ADDENDUM NO. 01

SYRACUSE HANCOCK INTERNATIONAL AIRPORT

RECONFIGURE TAXIWAYS C, F, B, E, AND G

June 6, 2018

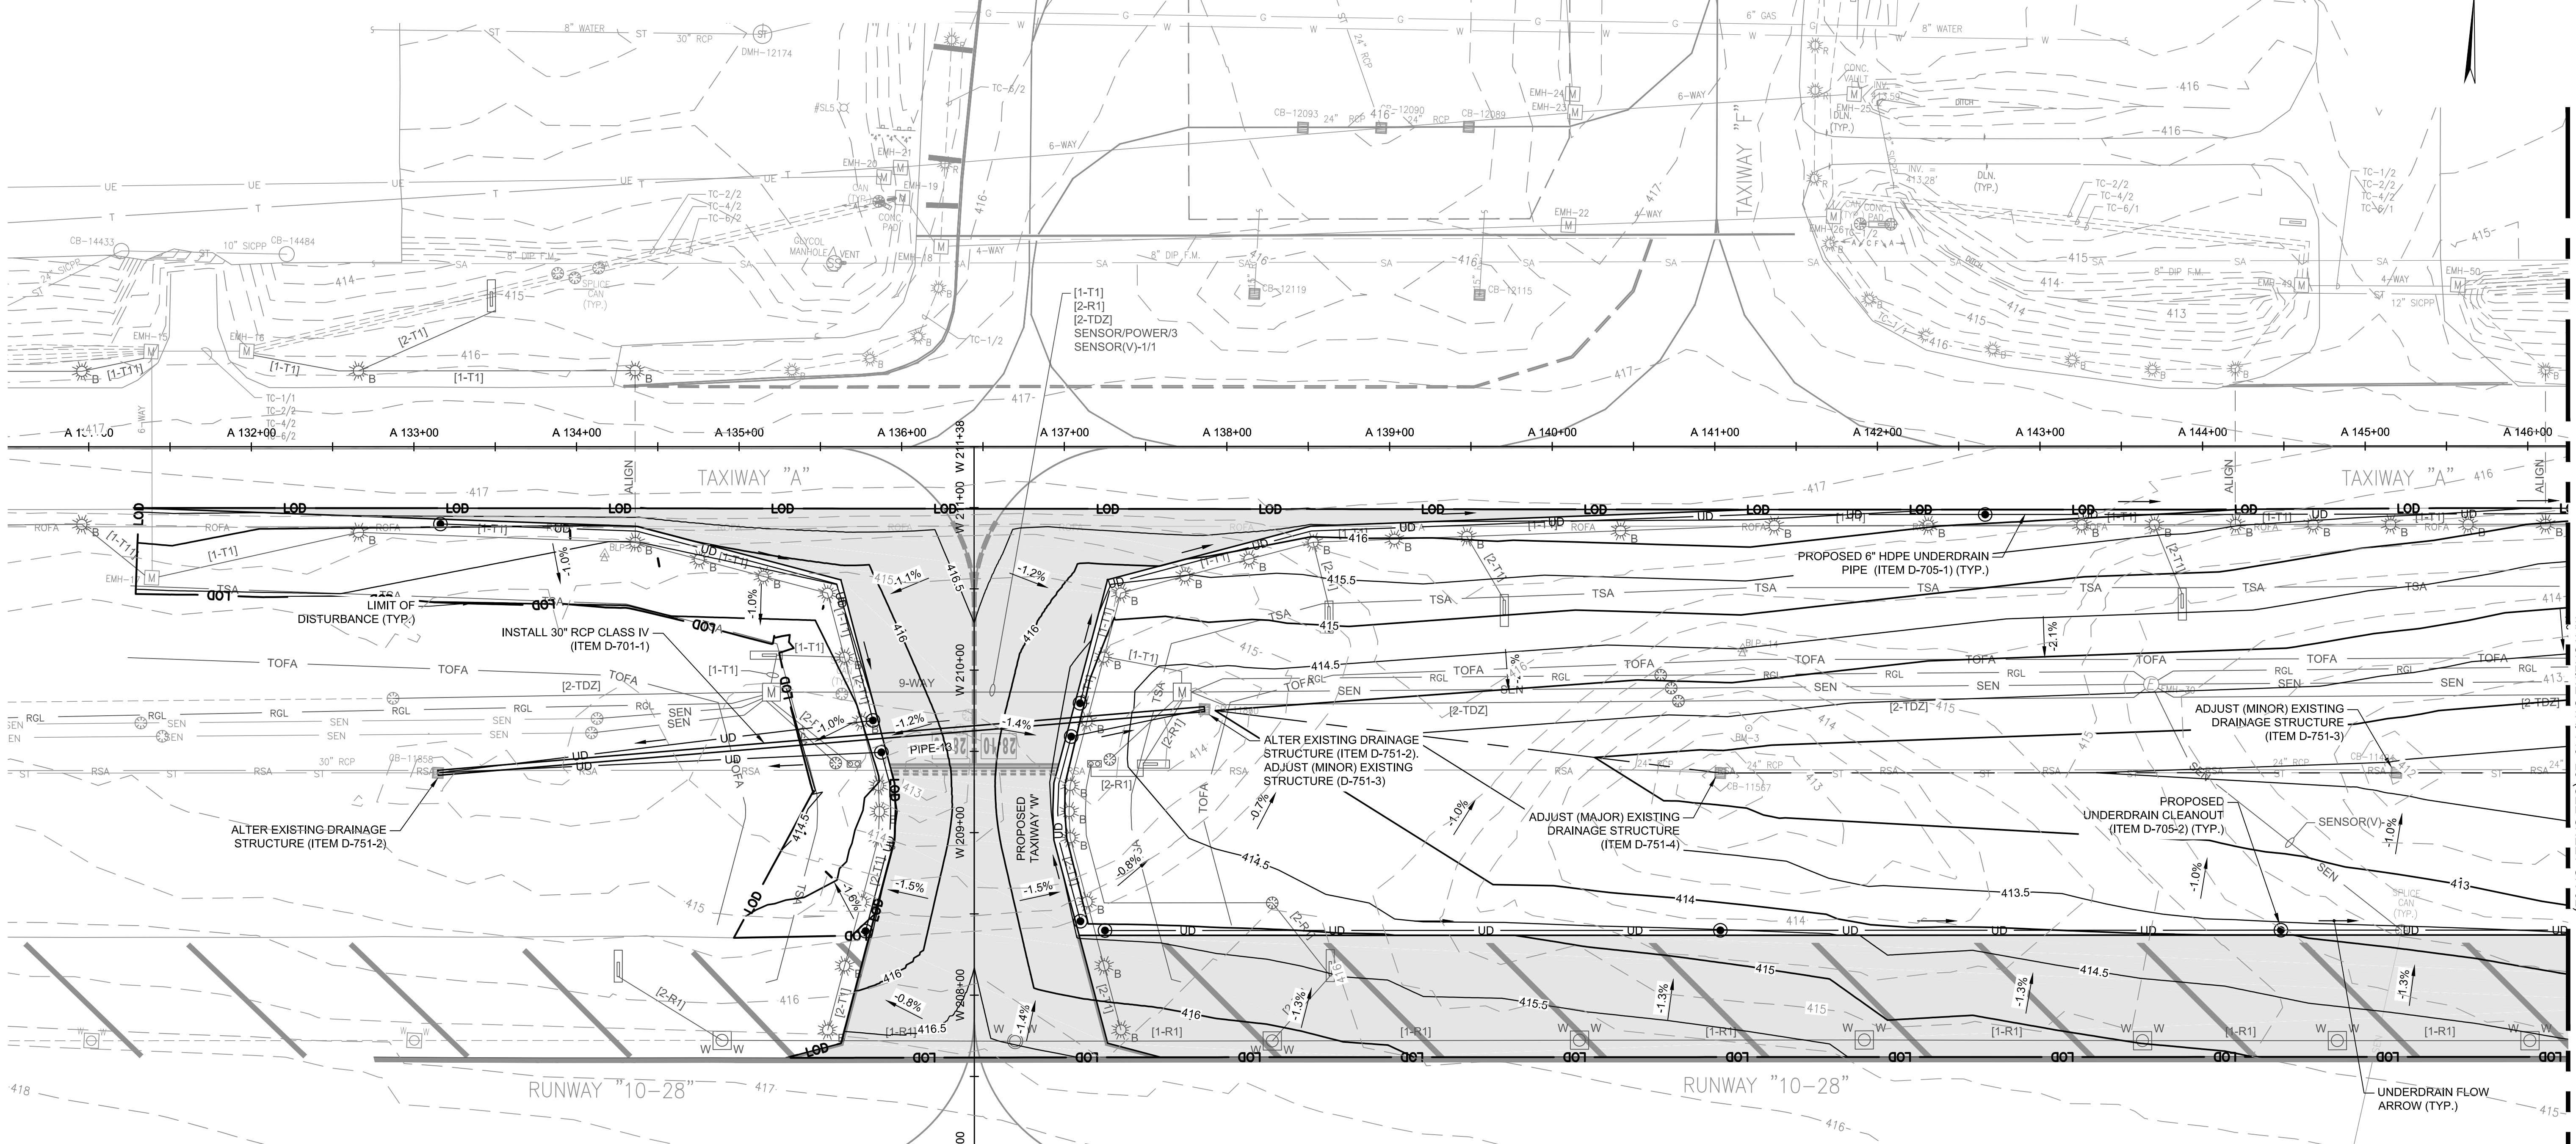
- e. TS-02 TYPICAL SECTIONS – 2
 - i. Added detail for Undercut Excavation and Backfill.
 - f. GR-01 GRADING & DRAINAGE PLAN (SHEET 1 OF 4)
 - i. Added existing contour labels.

SYRACUSE REGIONAL AIRPORT AUTHORITY
 CITY OF SYRACUSE, STATE OF NEW YORK
RECONFIGURE TAXIWAYS C, F, B, G, AND E
GRADING & DRAINAGE PLAN (SHEET 2 OF 4)

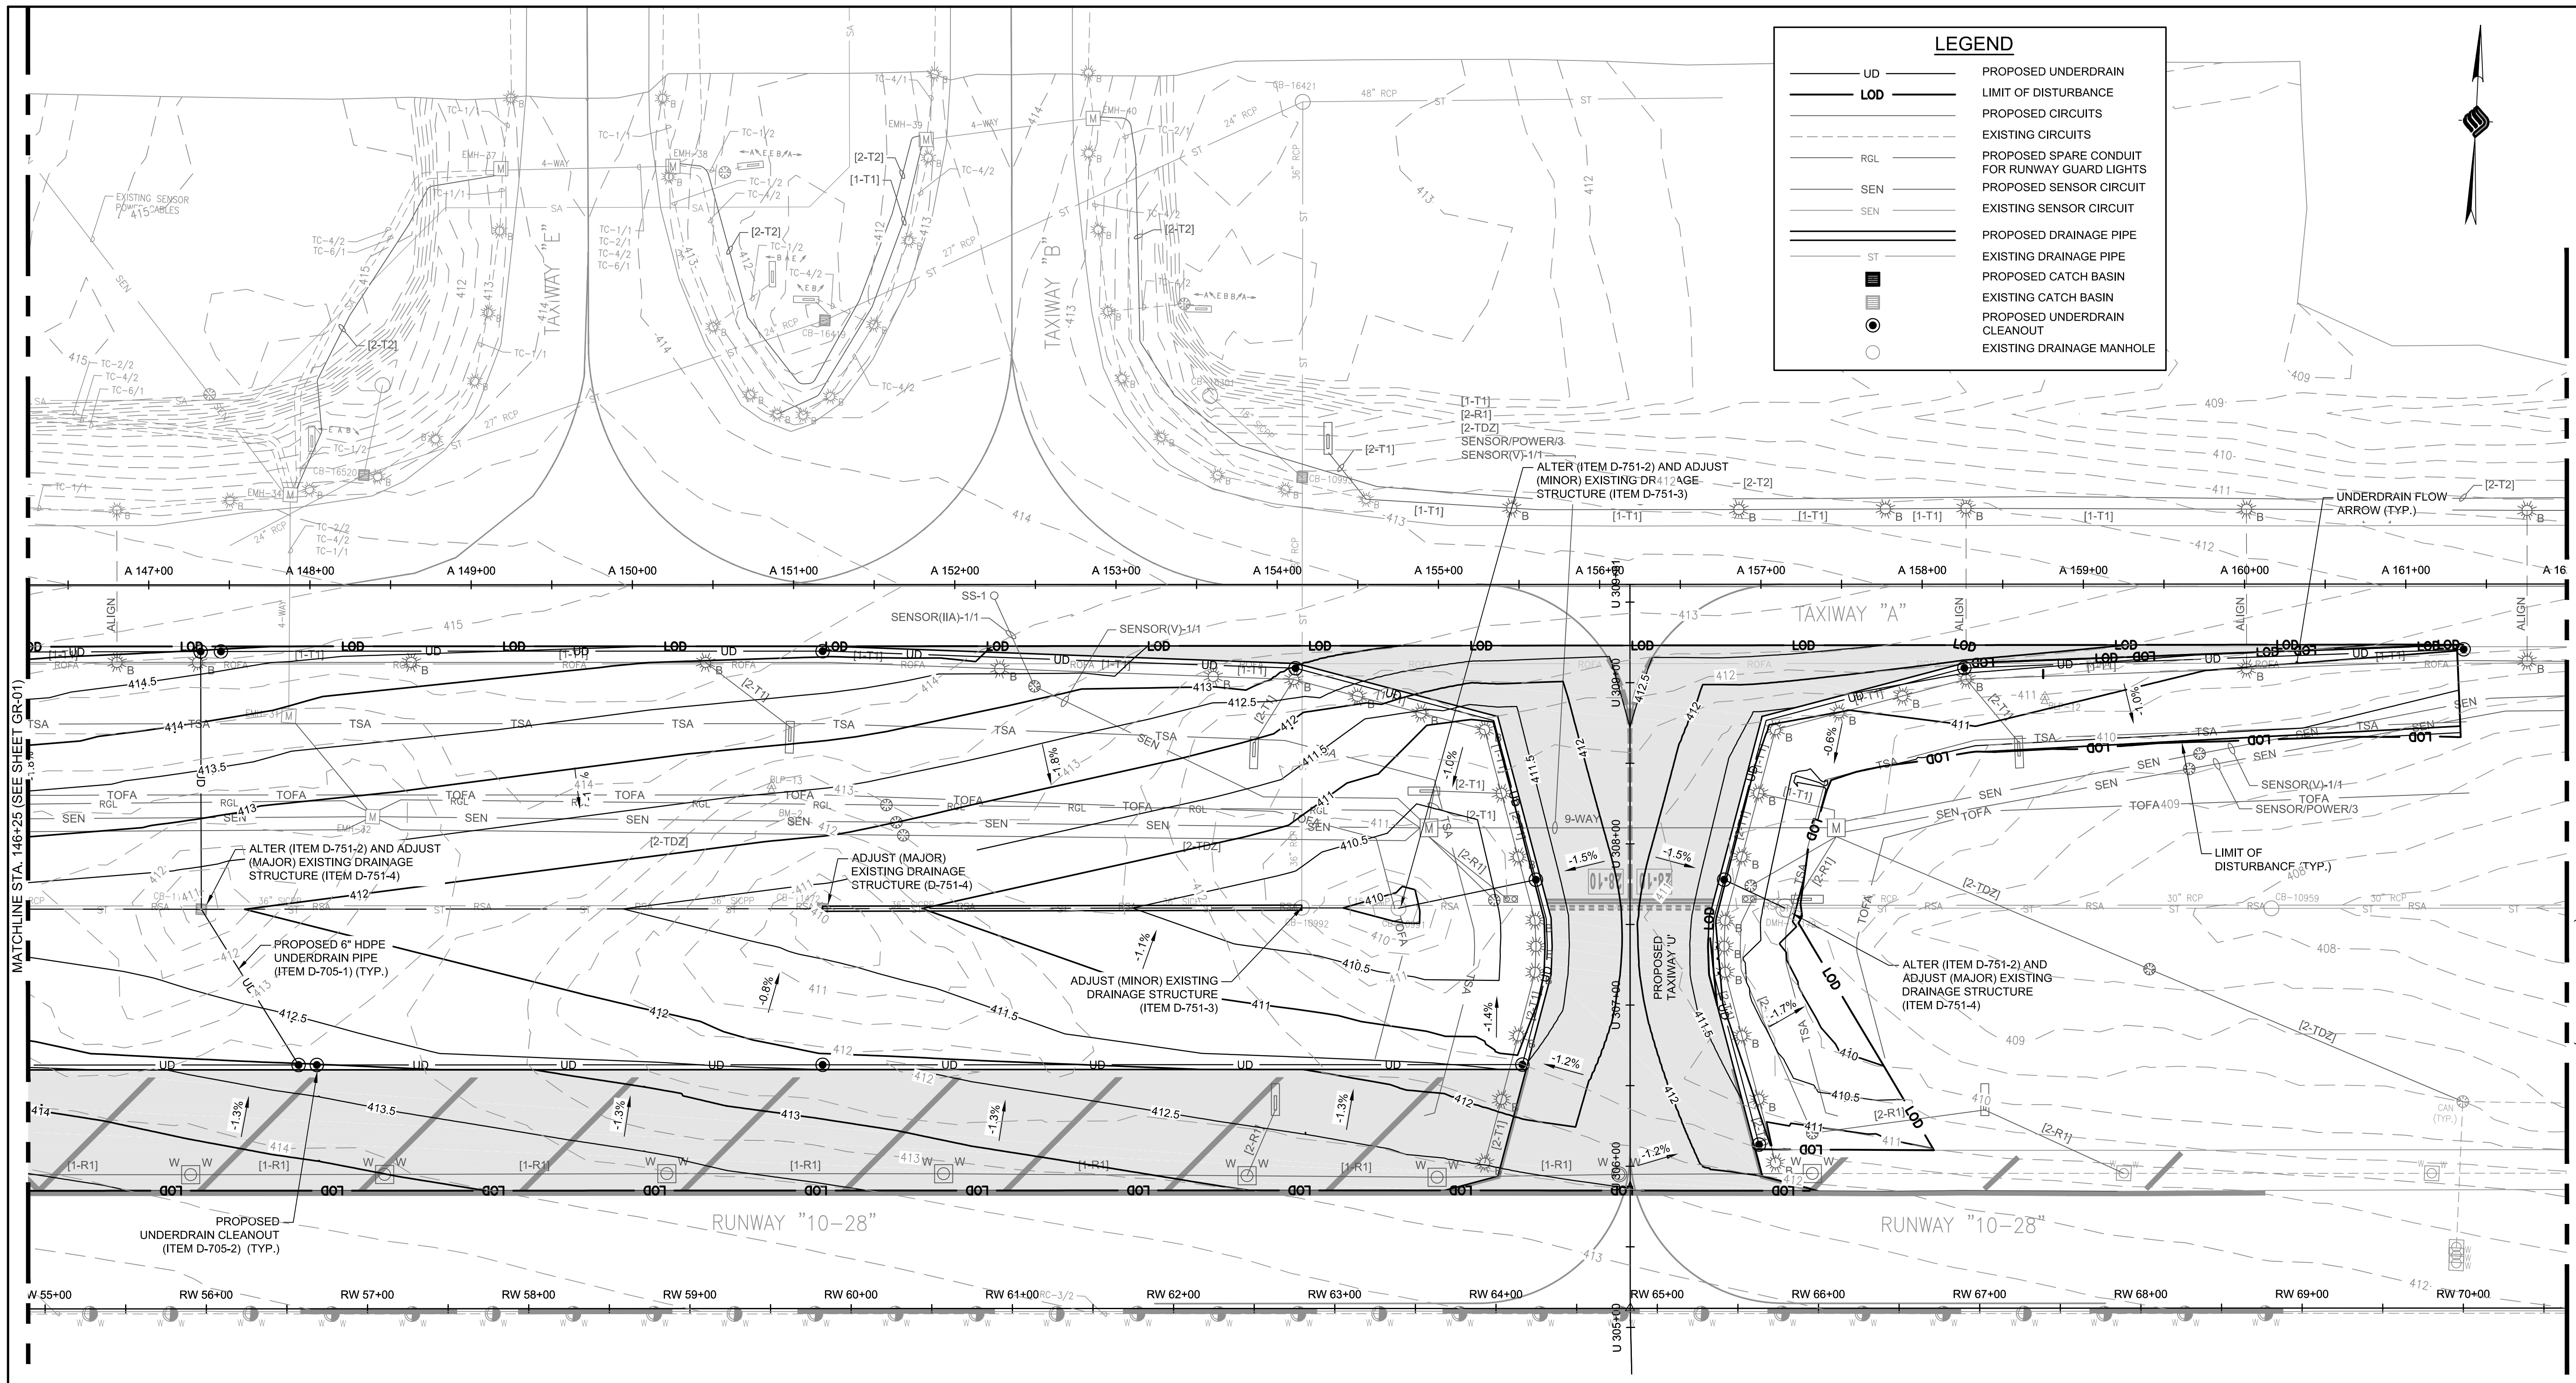
- g. GR-02 GRADING & DRAINAGE PLAN (SHEET 2 OF 4)
 - i. Added existing contour labels.
 - h. GR-03 GRADING & DRAINAGE PLAN (SHEET 3 OF 4)
 - i. Added existing contour labels.

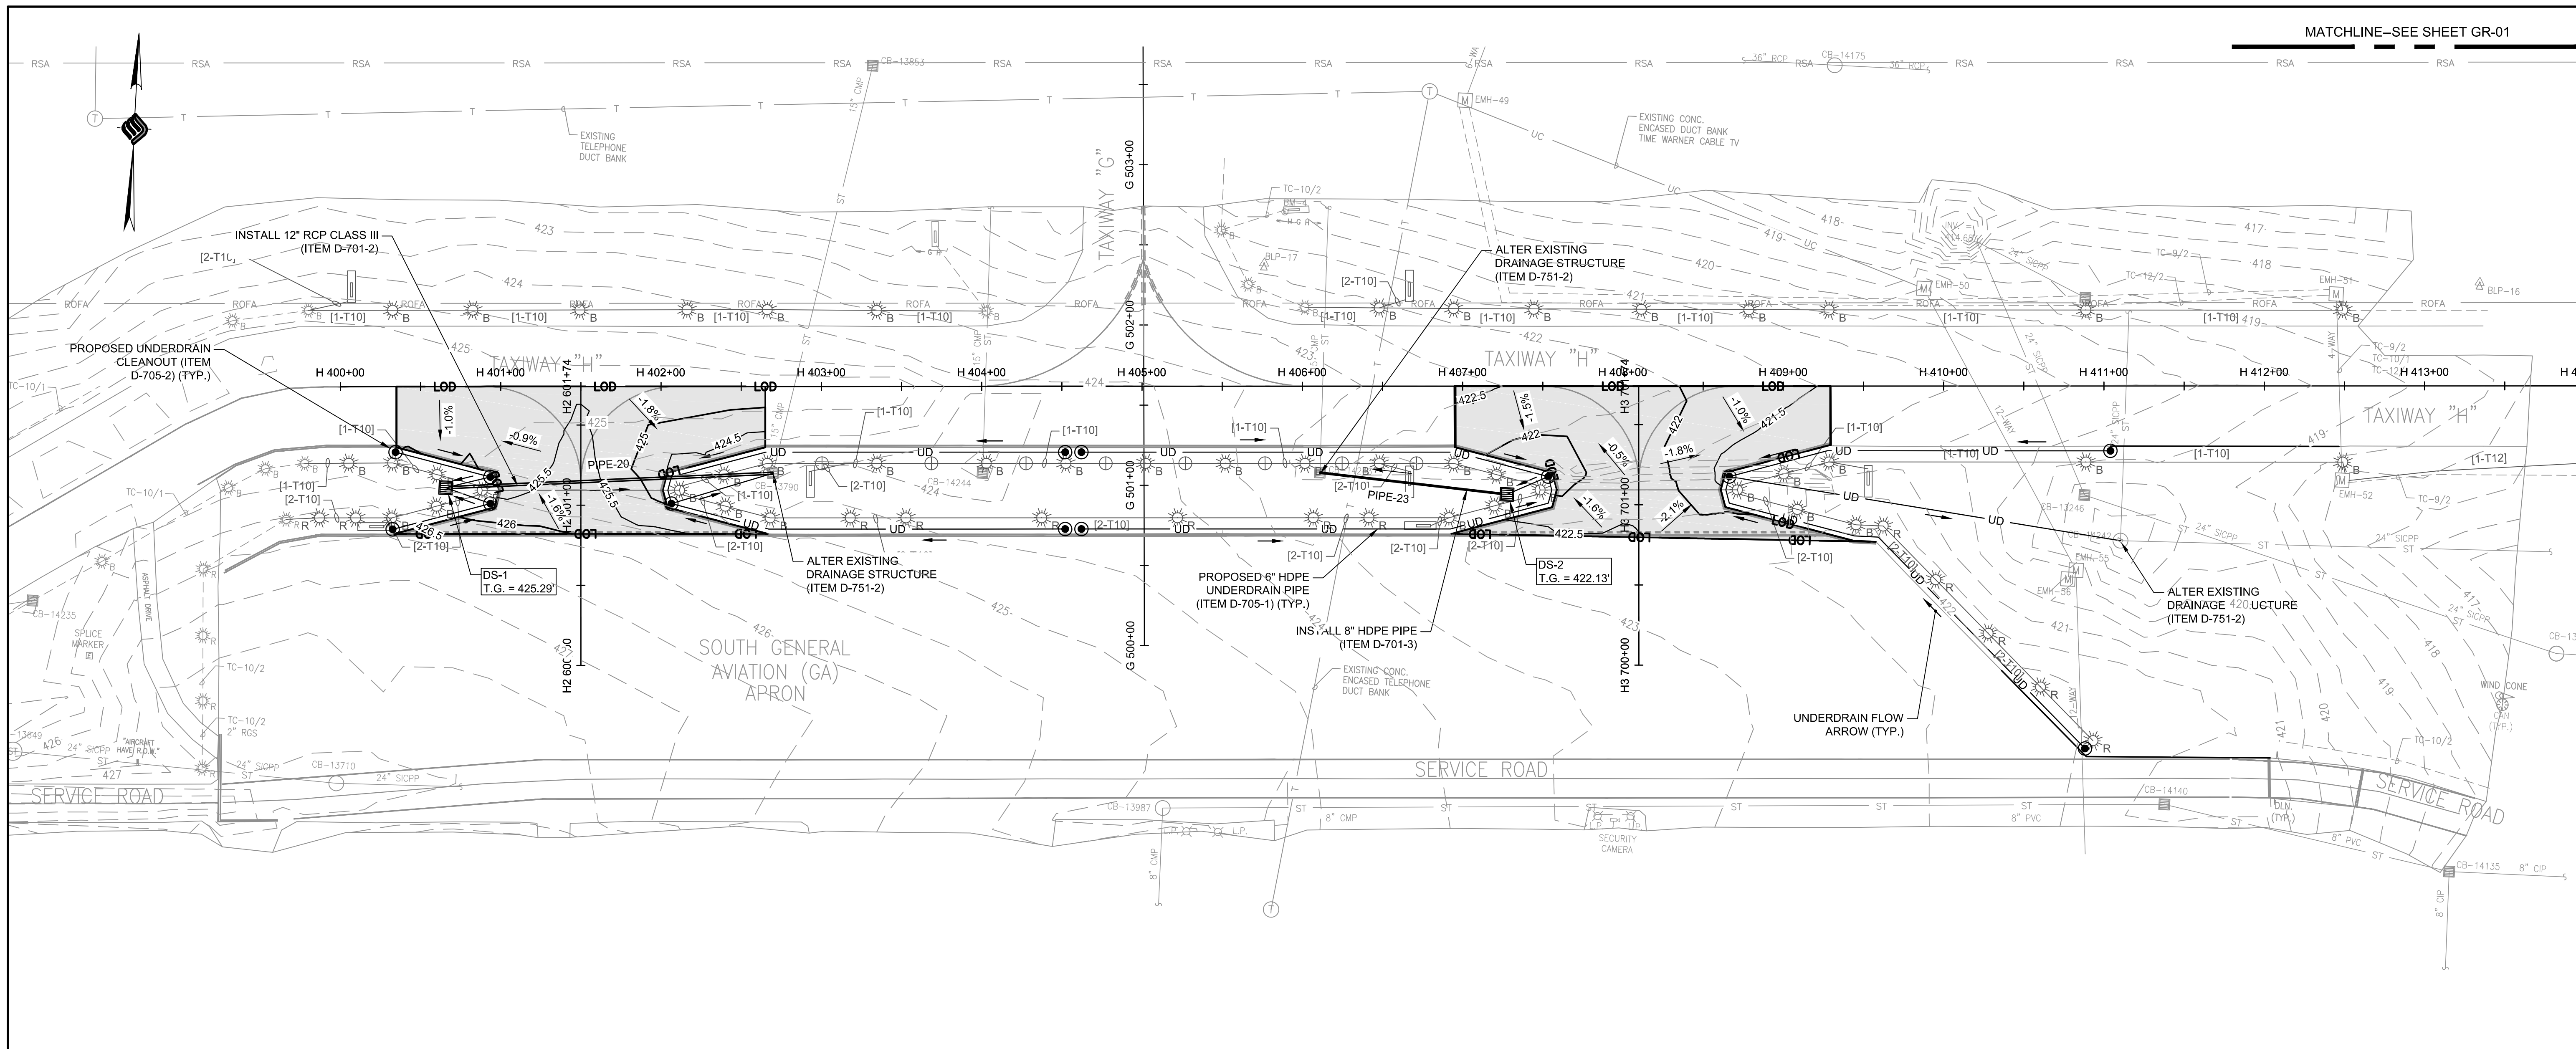
- i. GR-04 GRADING & DRAINAGE PLAN (SHEET 4 OF 4)
 - i. Added existing contour labels.
 - j. EC-01 EROSION & SEDIMENT CONTROL PLAN (SHEET 1 OF 4)
 - i. Added existing contour labels.
